## ADDENDUM 2

Project: NMHS Restroom Remodel

Invitation for Bid No.: 25-01-03

Issued by: Christopher Brown, AIA, Arkitek

- SKYLIGHT NOTES:**
- ALL DIMENSIONS TO LOCATE SKYLIGHTS ARE APPROXIMATE. SKYLIGHTS MUST BE LOCATED IN RELATION TO EXISTING TRUSSES AND CEILING GRIDS.
  - SKYLIGHTS HAVE BEEN LOCATED TO AVOID EXISTING DUCTWORK AS MUCH AS POSSIBLE. IF CONFLICT ARISES CONTACT THE ARCHITECT AT 541-488-0719.

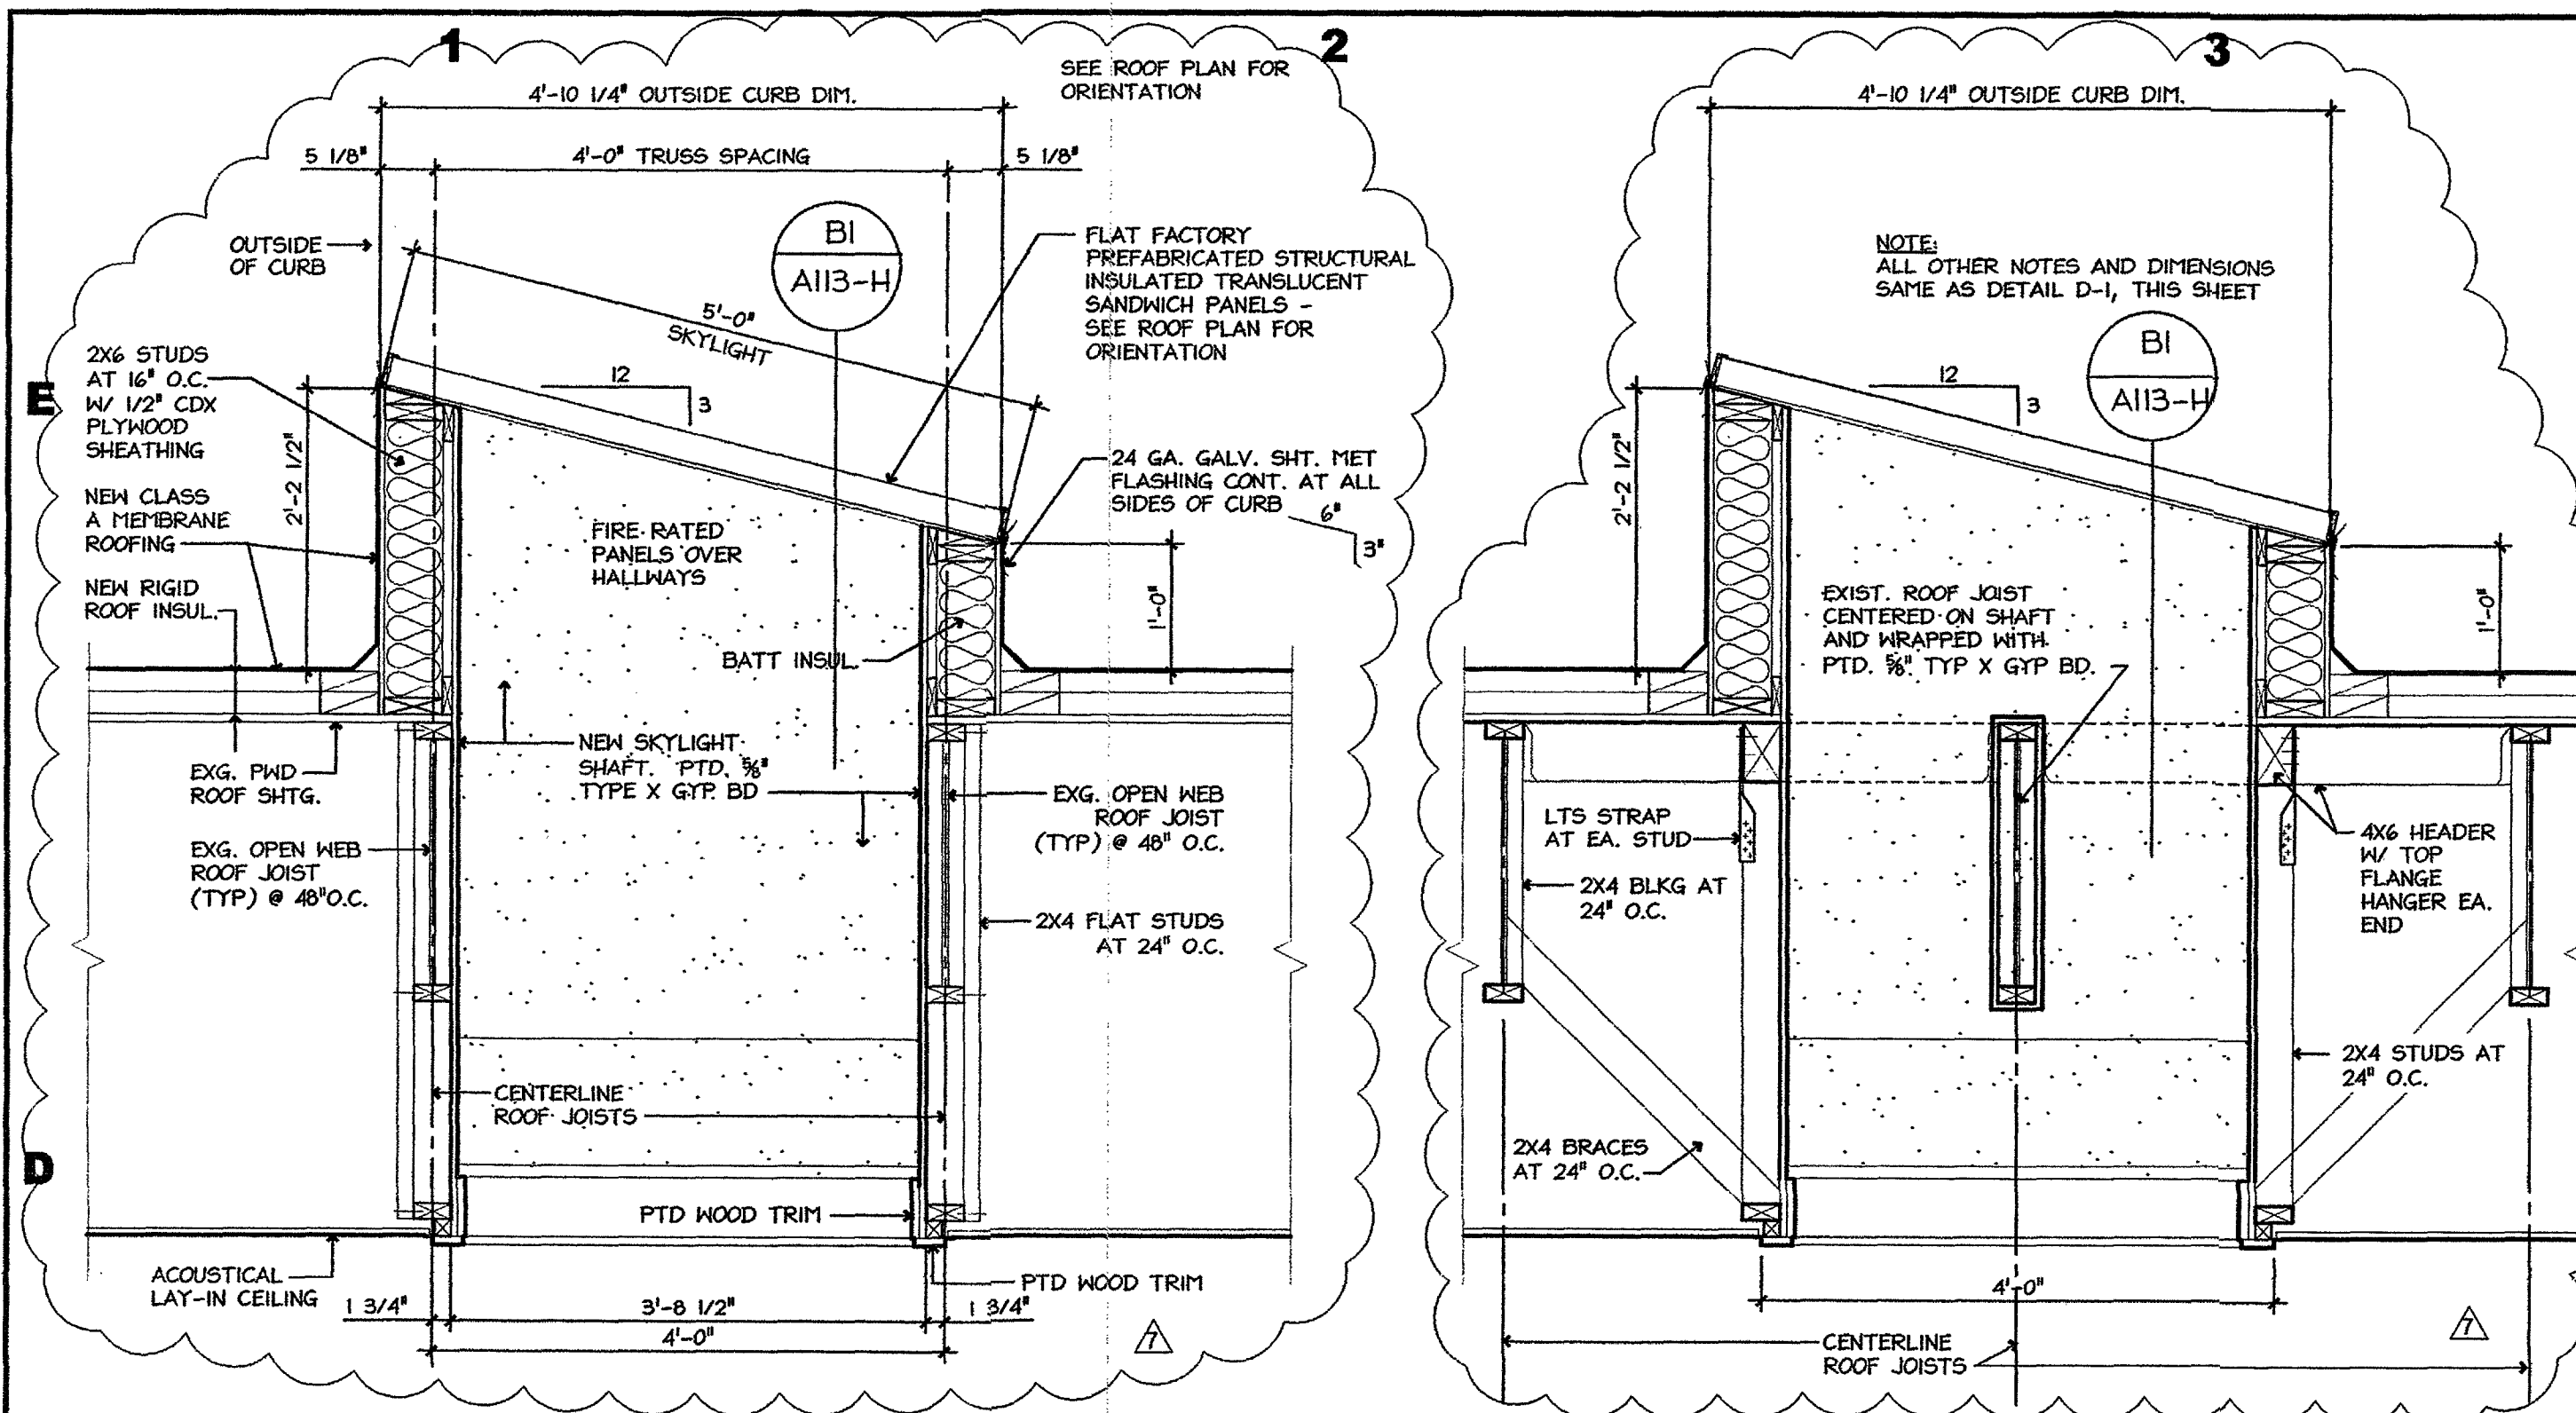
4. Please provide an existing roof detail for patching work at the new exhaust fan EF-B2.  
See the pdf attached with existing roof details from a previous remodel (Pages from NMHS as-builts 2008 – Building ‘H’ Remodel.pdf).
